Office Action Summary	Application No. 18/698,915	Applicant(s) MORISHIMA et al.	
	Examiner Eric K Wong	Art Unit 2874	AIA (First Inventor to File) Status Yes

DETAILED ACTION

FIG. 4A

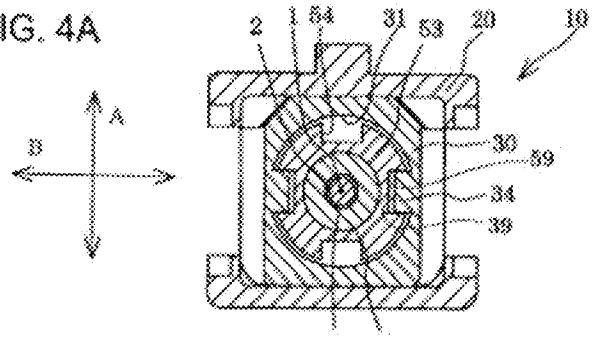
Inagaki discloses a round-type profile having a recess between two contact points (figure 4A).

It would have been obvious to one having ordinary skill in the art to swap the recess portion to be between two contact points as taught in Tiara in the square-type shape of Shimikawa as a design choice for a change in size, shape, rearrangement or reversal of parts. *In re Japikse*, 86 USPQ 70, *In re Rose*, 105 USPQ 237 (CCPA 1955), *In re Einstein*, 8 USPQ 167.
